TOWN OF PORTOLA VALLEY
REGULAR PLANNING COMMISSION MEETING
765 Portola Road, Portola Valley, CA 94028
Wednesday, May 7, 2014 – 7:30 p.m.
Council Chambers (Historic Schoolhouse)

1. *Public Hearing* – Proposed Revision to Approval of Variance Request X7E-135, 3 Grove Court, Ciancutti
2. *Public Hearing* – Site Development Permit X9H-672 for 18 Redberry Ridge, Blue Oaks Lot #15, Douglass/LaShay Residence
3. Continued Study Session – Housing Element Update
4. Review of Housing Element Annual Report for 2013

TO: Planning Commission
FROM: Karen Kristiansson, Interim Town Planner
DATE: May 1, 2014
RE: Agenda for May 7, 2014 Planning Commission Meeting

PROJECT: 18 REDBERRY RIDGE
 SHEET: C-2
 DATE: 07/20/14
 DRAWING NO: 2014-12
 SHEET: 2 OF 2

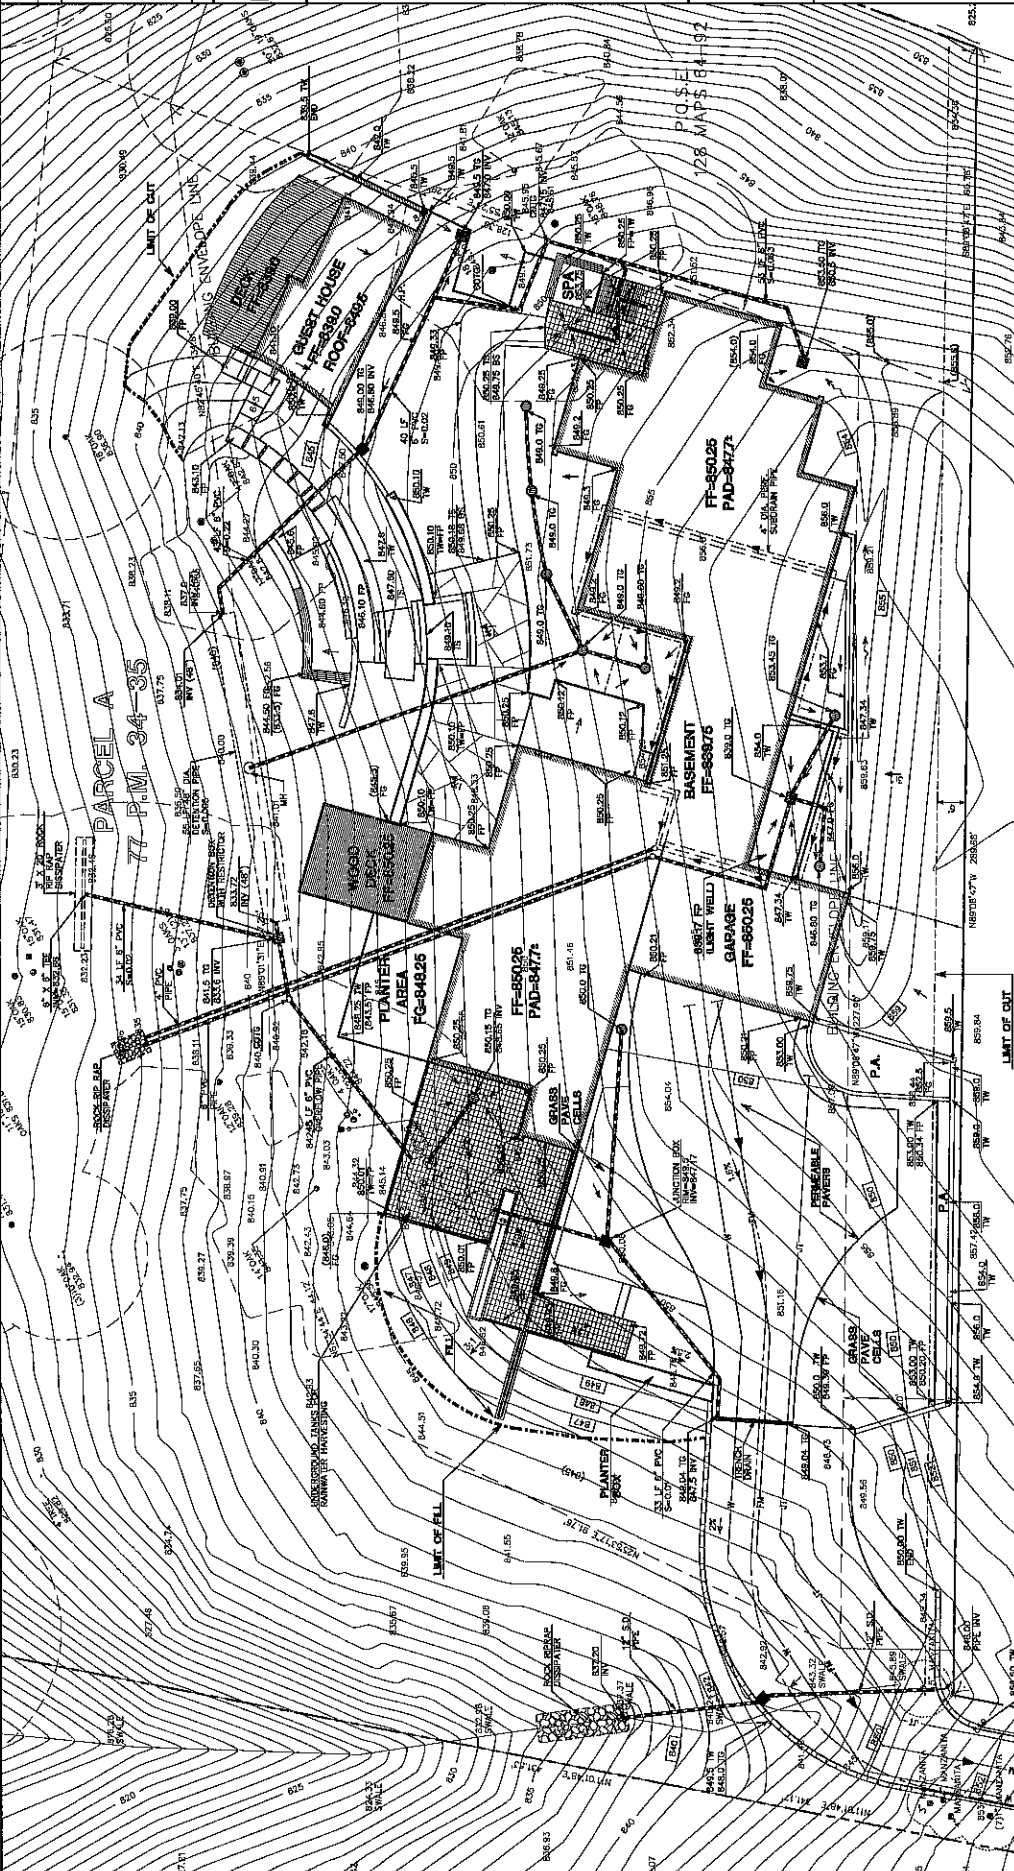
1. **Driveway swale crossing.** The revised plans now show a 12" culvert for the driveway crossing of the swale, with backfill against the retaining wall to reduce the visual impact, as shown on Sheet C-2 and in Section B on Sheet C-3. As was reported at the March 24th ASCC meeting, a civil engineer reviewed the drainage conditions at the swale and recommended a 12" culvert pipe (attached). These calculations would be reviewed by the town's engineering consultant as part of the normal building permit process.

The plans indicate that the driveway over the swale would have an approximately six foot tall retaining wall on the north side. Dirt would be backfilled against the retaining wall to a slope of 3:1 in order to reduce the visibility of the exposed wall from off-site. At the meeting on April 14, the project team should provide information concerning the height of the retaining wall that will likely be visible above the fill, as the section that was provided on Sheet C-3 in the plans is not to scale.

- 6. North retaining walls and terraces.** As shown on the grading plan (Sheet C-2), the terrace area between the dining room and the second unit includes a system of retaining walls. The largest of these is approximately 30' long and runs from the overlook terrace to the stairs down to the second unit, and ranges in height from 4.5' to approximately 2'. There is another wall, about one foot tall, on the other side of the stairs which continues about 21' towards the second unit. The planting plan (Sheet L4.0) shows vegetation planted in front of both of these retaining walls, including grasses and some shrubs, which would help to screen the retaining walls from view from the north.

7. **Revised grading plans and site development permit.** The grading plans have been updated to reflect the new design, although the cut and fill calculations on Sheet C-2 have not. The total volume of grading would be 1,520 cubic yards calculated according to the standards of the site development ordinance (the 1,275 cubic yards indicated on the grading plan, plus 245 cubic yards of cut to lower the bedroom wing). Approximately 2,900 cubic yards of materials would be exported from the site, much of this for cutting of the proposed basement and guest house, and for excavation within the footprint of the house (areas where the cut does not count under the site development ordinance provisions).

Sheet: L2.1 of 2

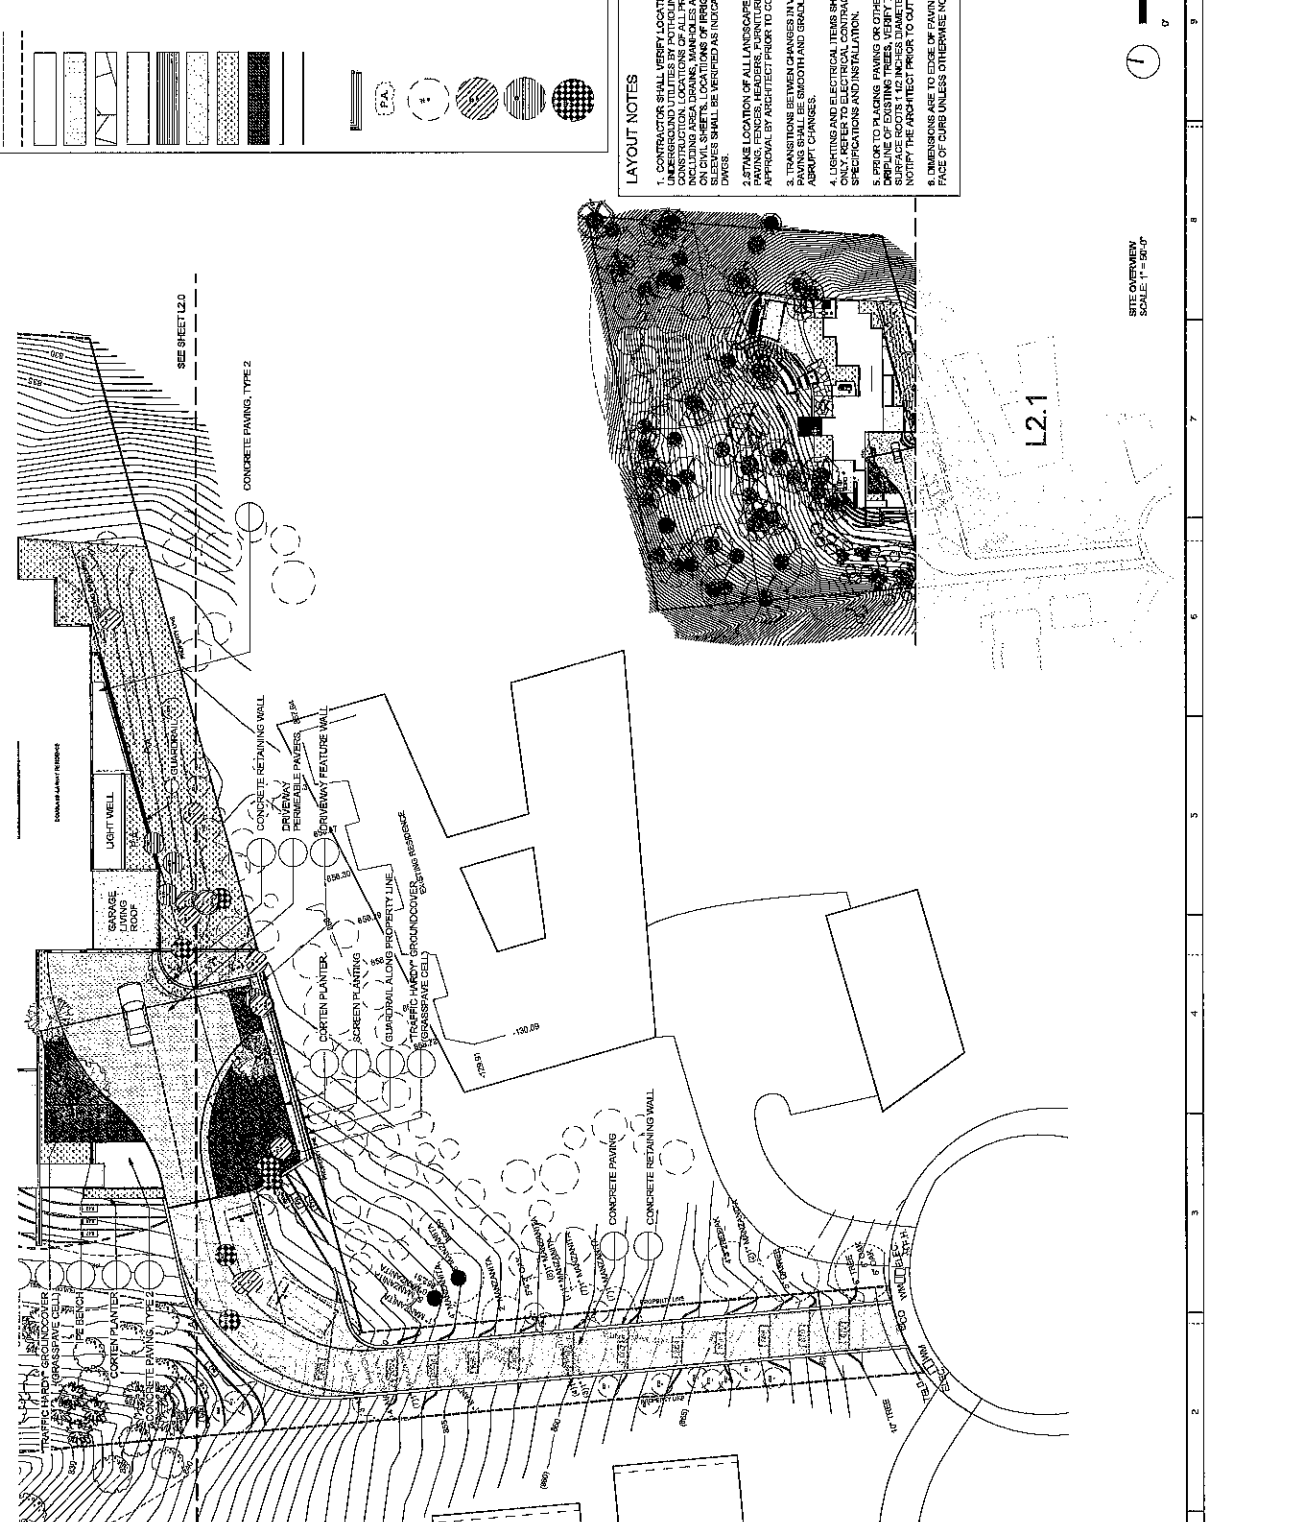
One item that will need clarification is the surface for the driveway in the panhandle, which Sheet L2.1 identifies as "concrete/asphalt paving." The materials should be specified to the satisfaction of the ASCC.
